Special Bulletin

SP16-306A

INNER FENDER PANEL REPLACEMENT

Prevost vehicles

Figure 1

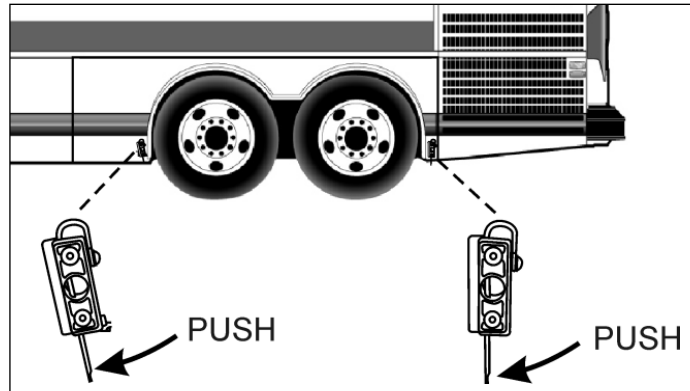
- 1) Release the rear road side (left) fender (Fig 1) by pushing the spring rods.
